Airport Advertising RFP Addendum

DES MOINES INTERNATIONAL AIRPORT
LIFT DSM PASSENGER TERMINAL

CONCOURSE PET RELIEF - WEST G5

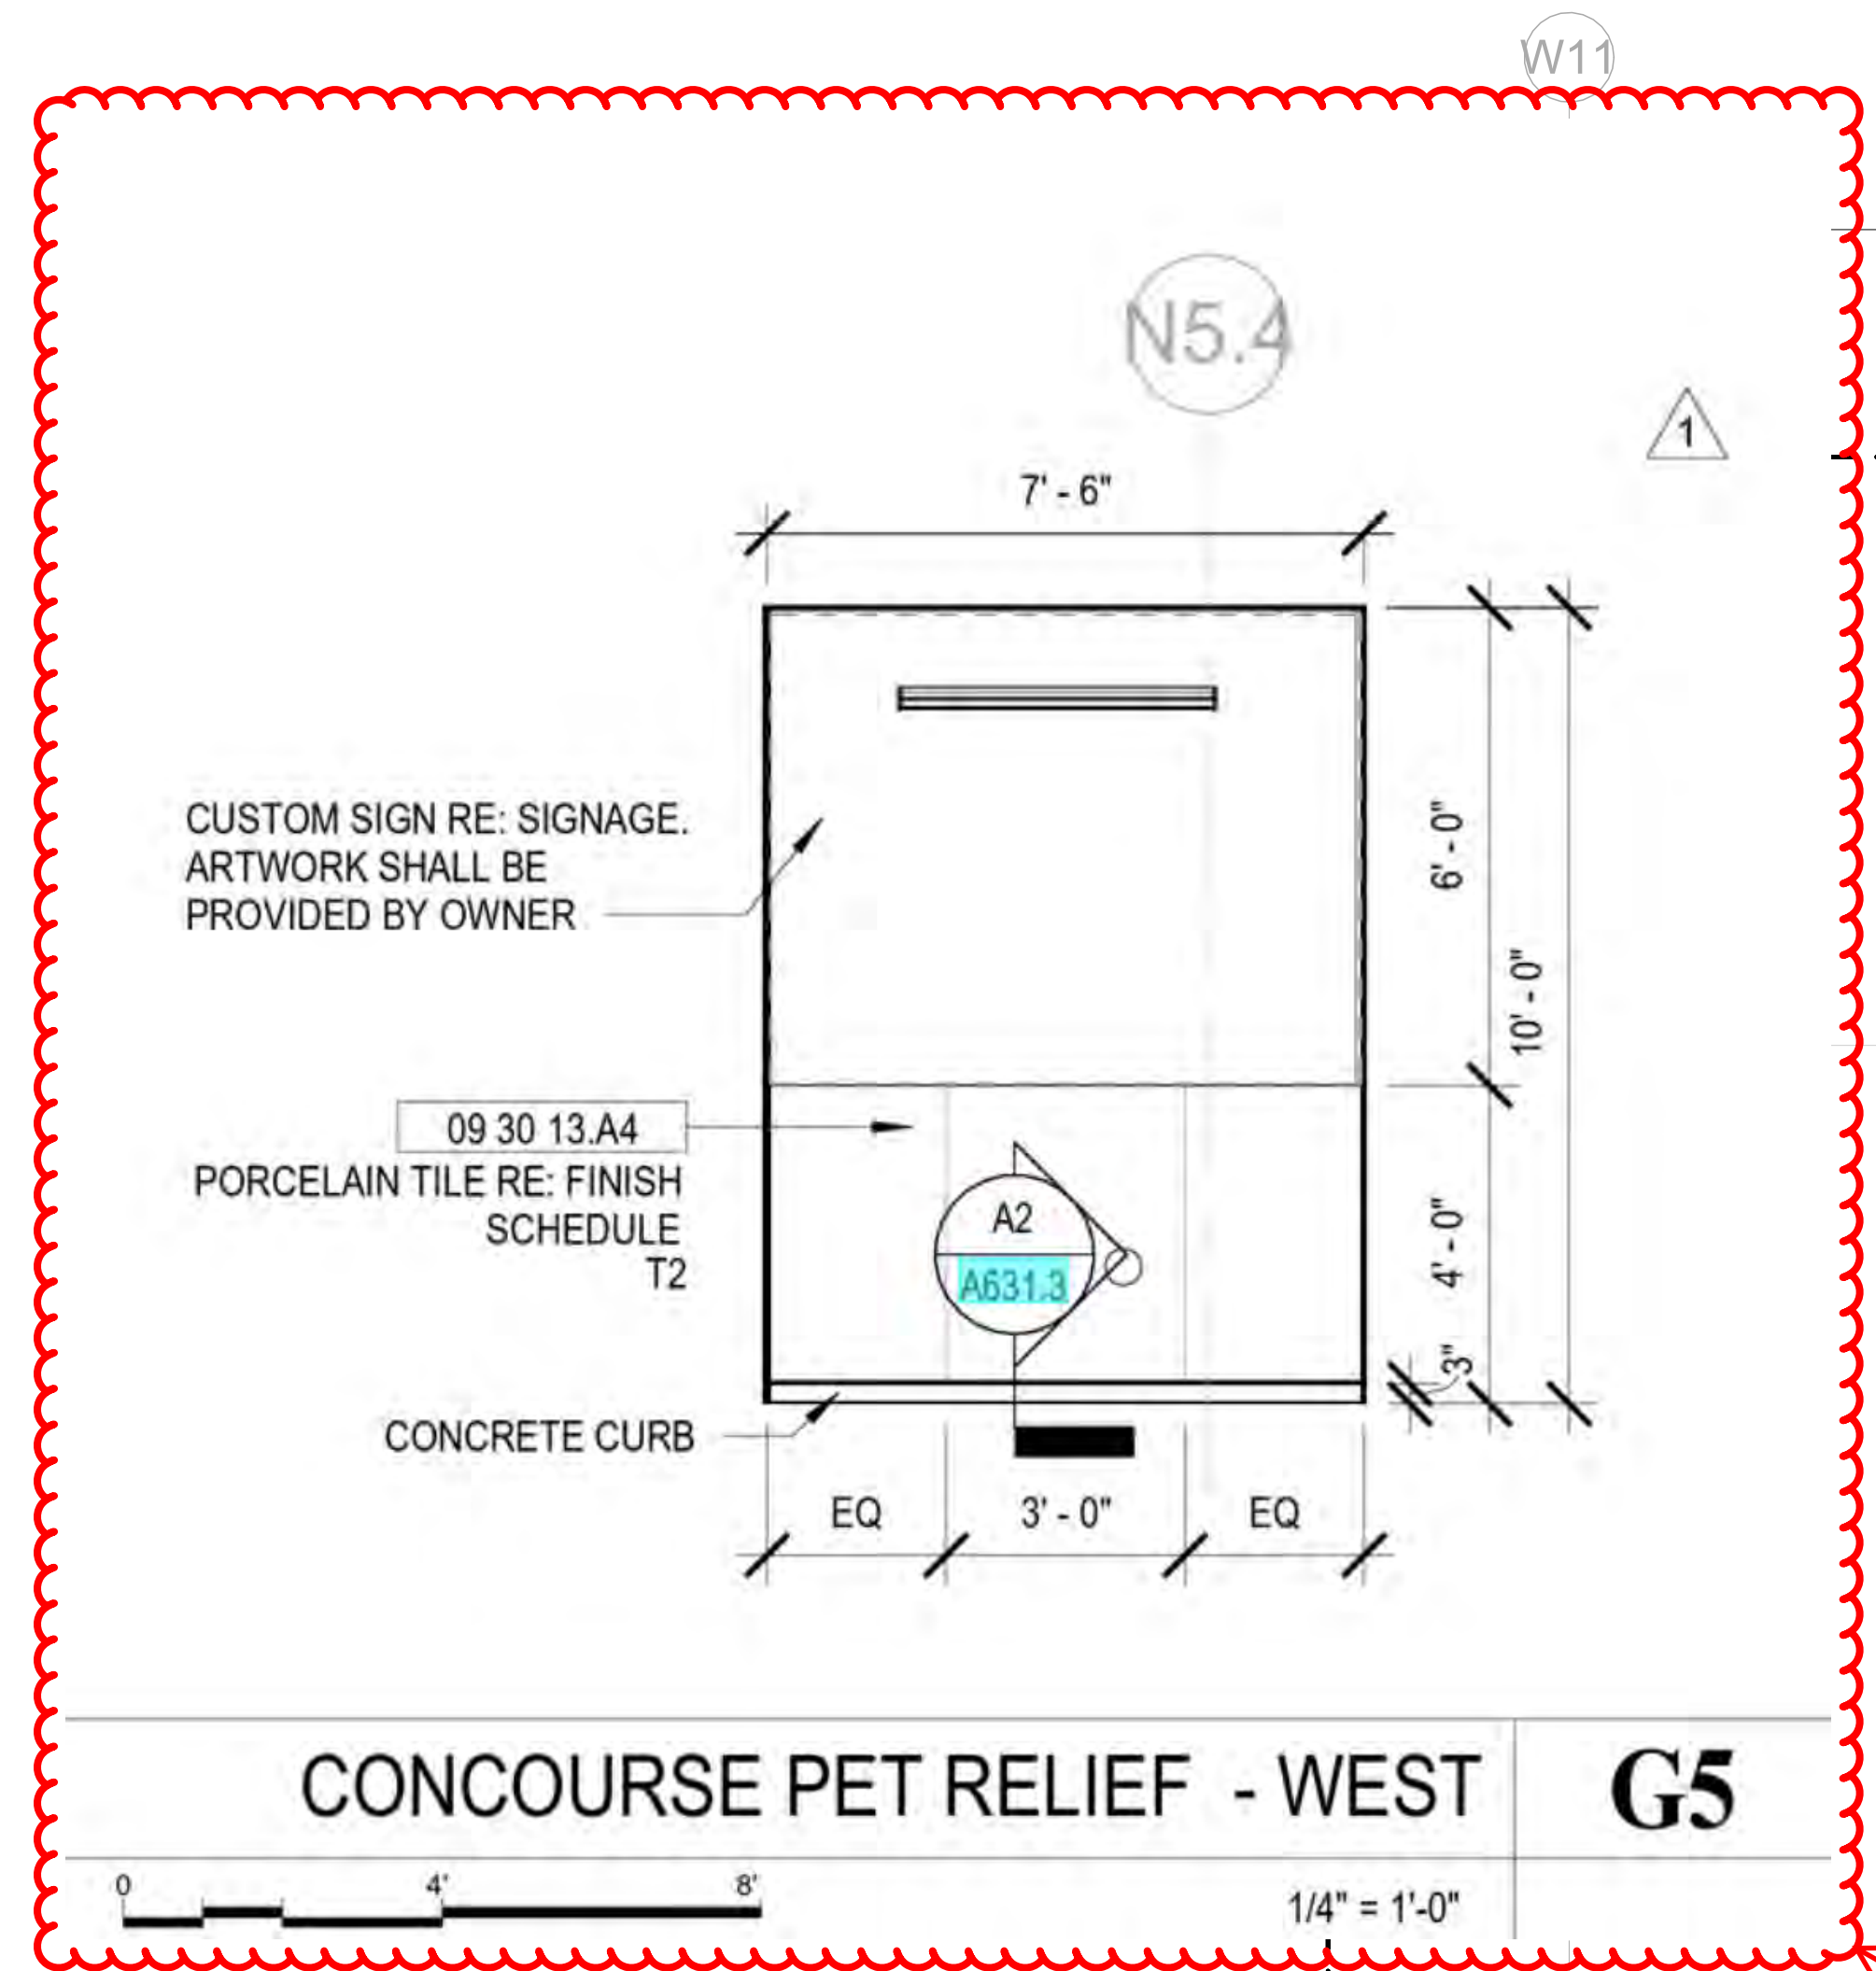
10) Pet Relief Area - What is the material that will be installed behind the advertisement? Is there a preferred material the Airport prefers for this other than it needs to be washable?

A. This area is still being finalized and finish materials have not yet been determined. The Airport does not have a specified preferred material at this time, other than that it must be washable. The Airport will review and approve the final product proposed prior to installation.

CONCOURSE PLAN - SECTOR A7 A1

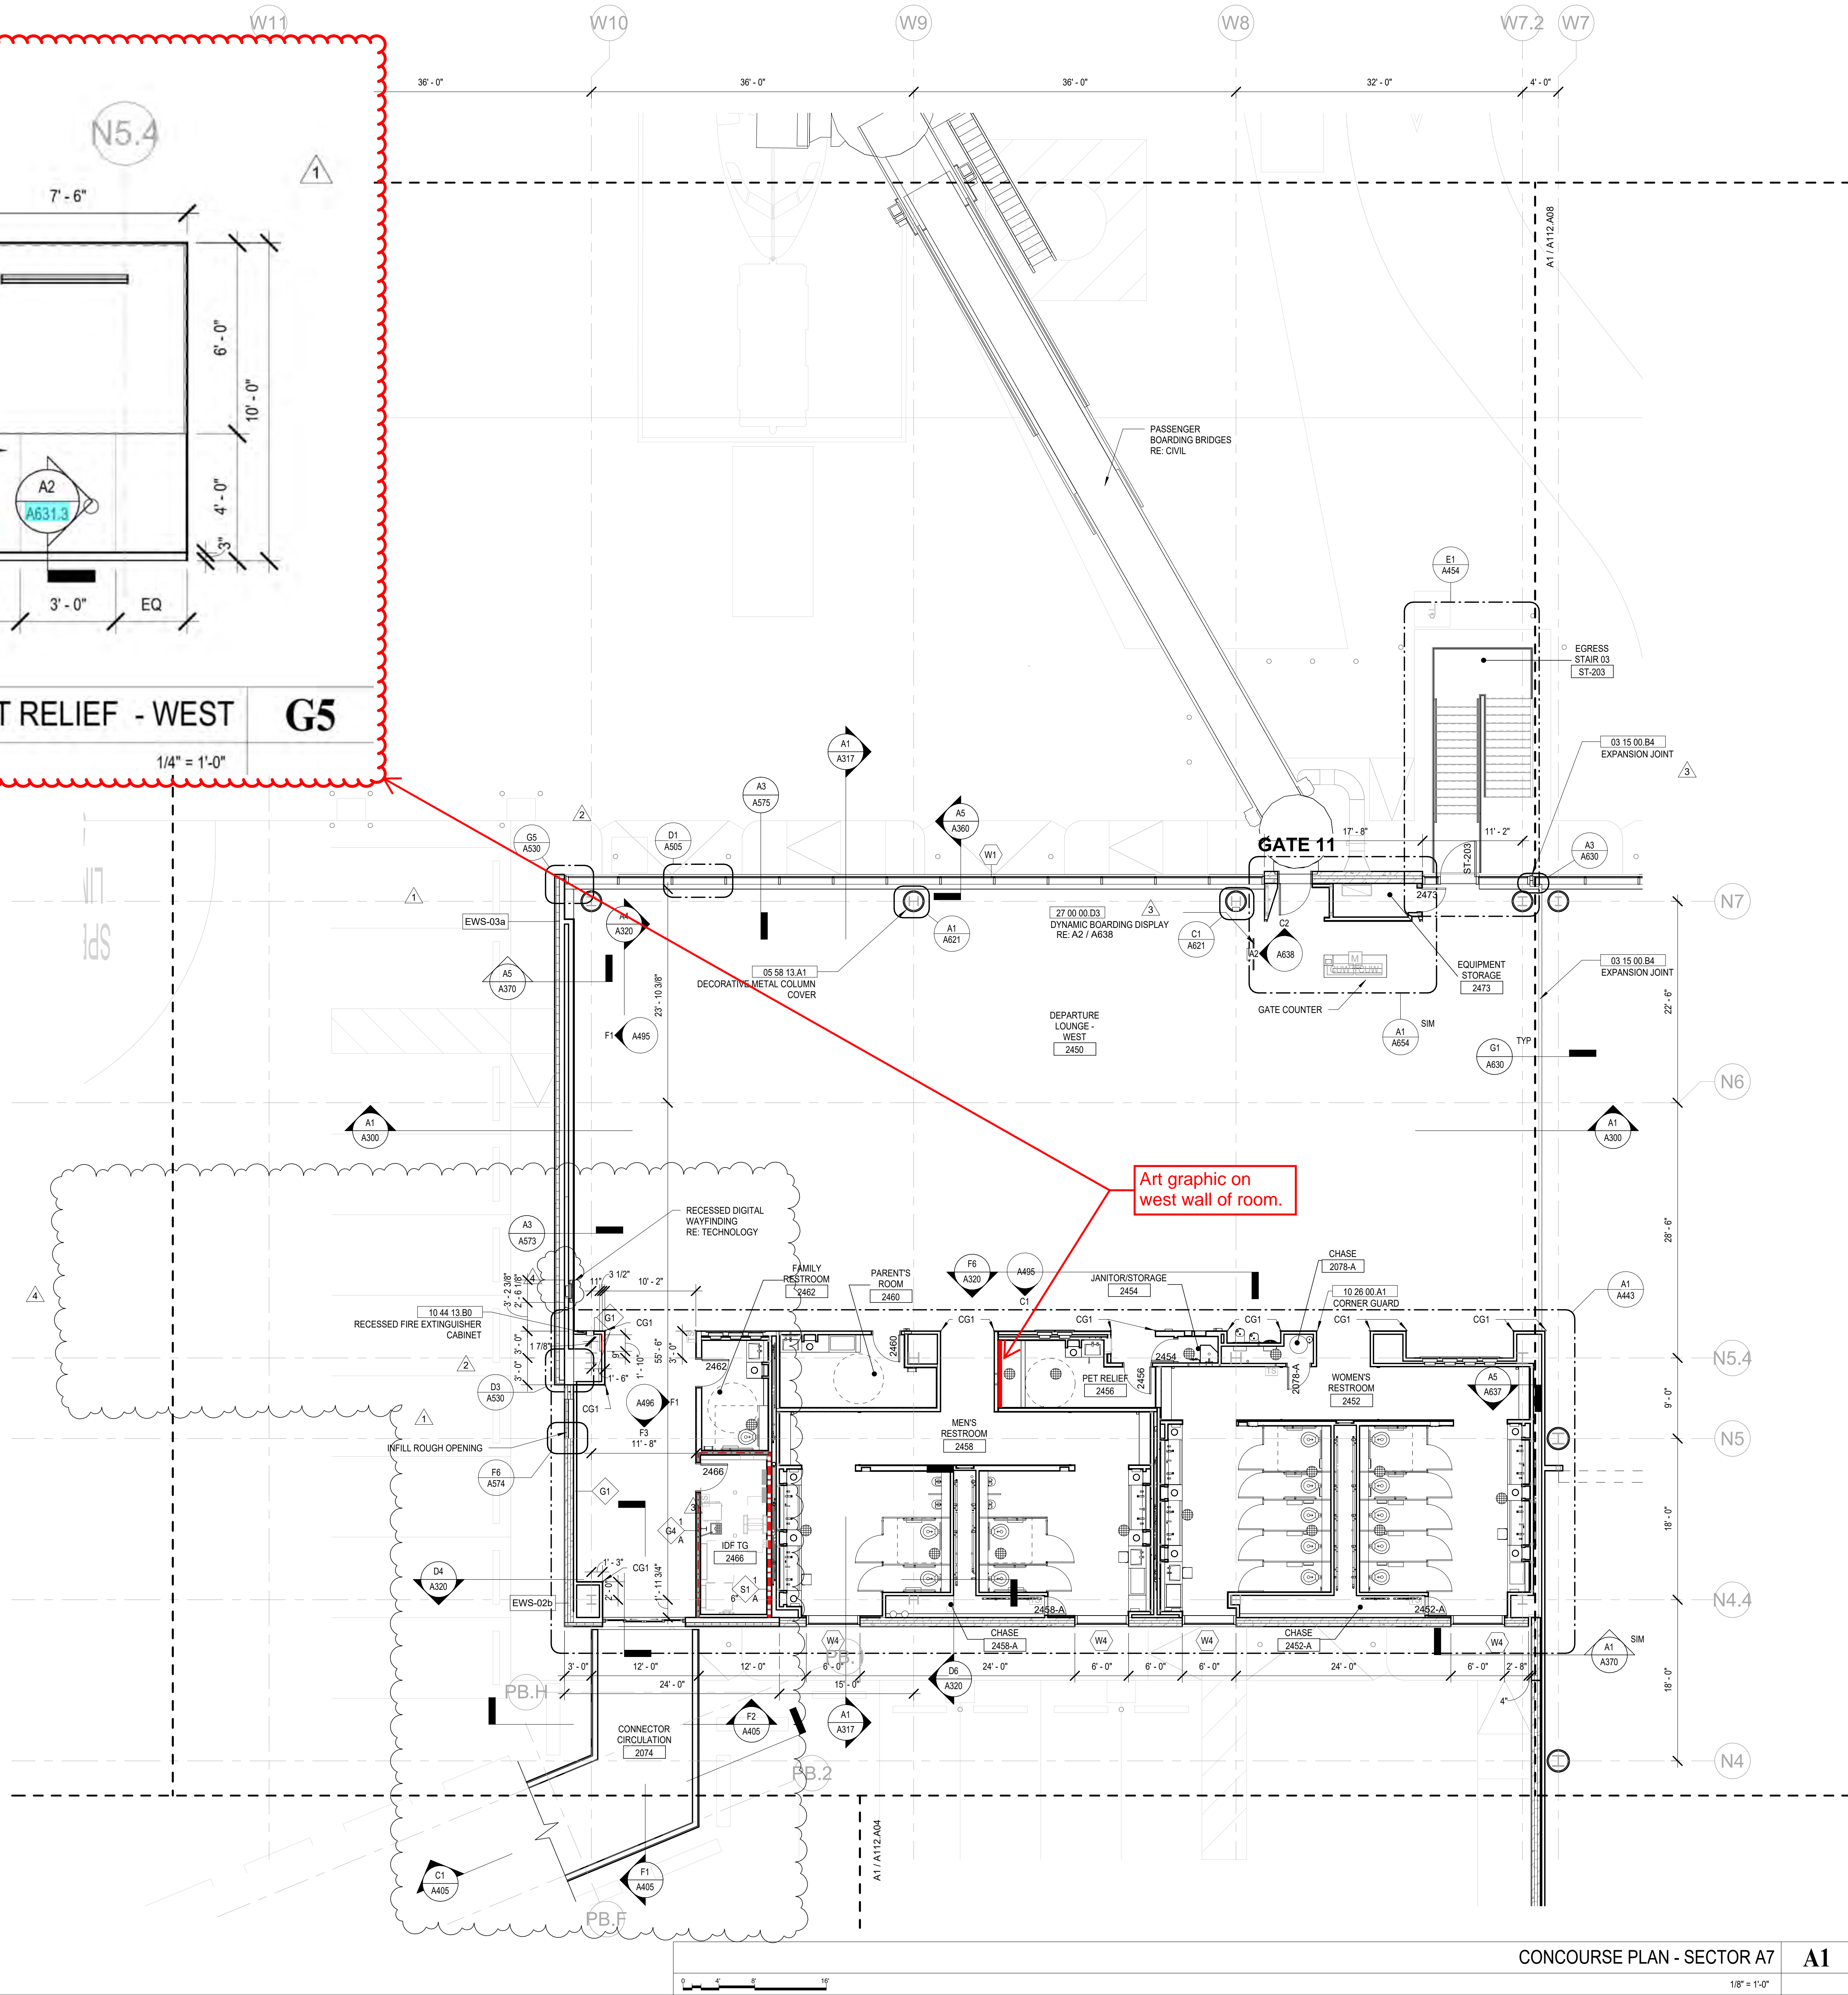
5) Size of each advertising recessed space

A. The locations are currently being finalized, and precise measurements will be provided to the awarded Proposer once the finishes have been installed. In the meantime, please refer to the provided diagram, which identifies each monitor size.

EXHIBIT A-9
LEASED PREMISES—DISPLAY LOCATIONS
Rental Car Center

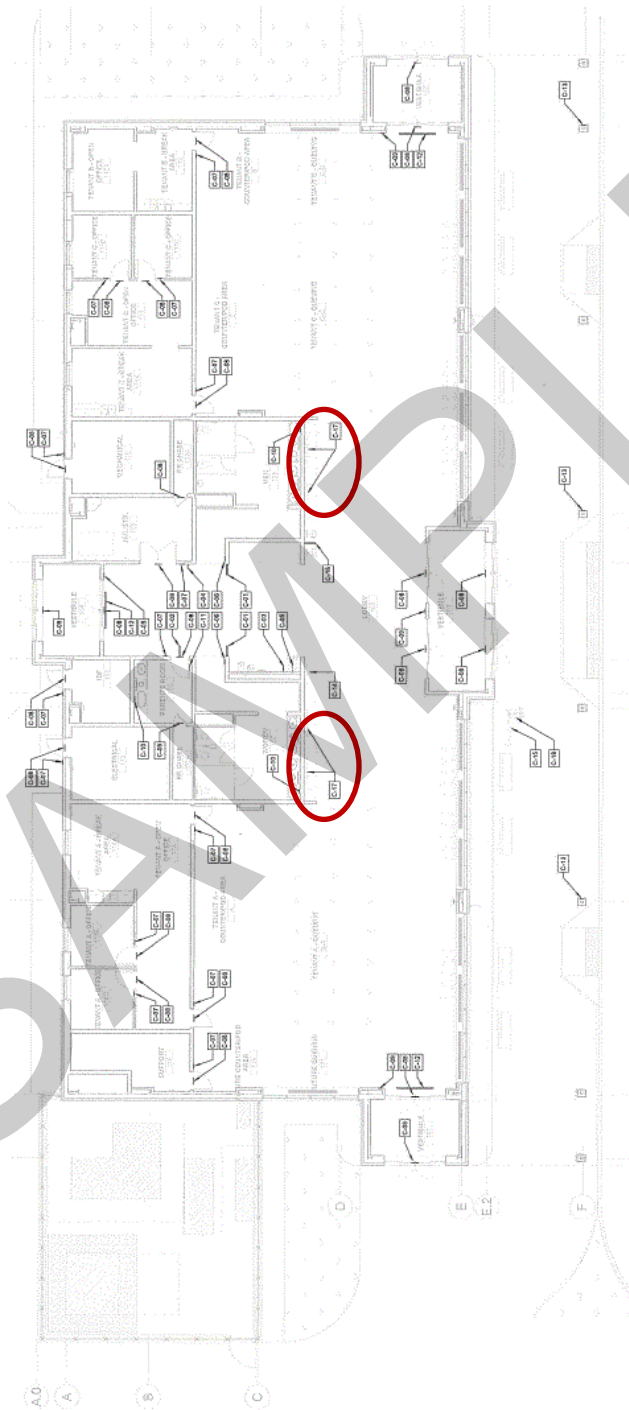
34) Advertising locations are not identified on the maps provided in Exhibits A8–A10. Please confirm whether Respondents should propose a display plan and associated locations for these areas as part of their submission.

55" Monitors
2 locations on each
side - total of 4
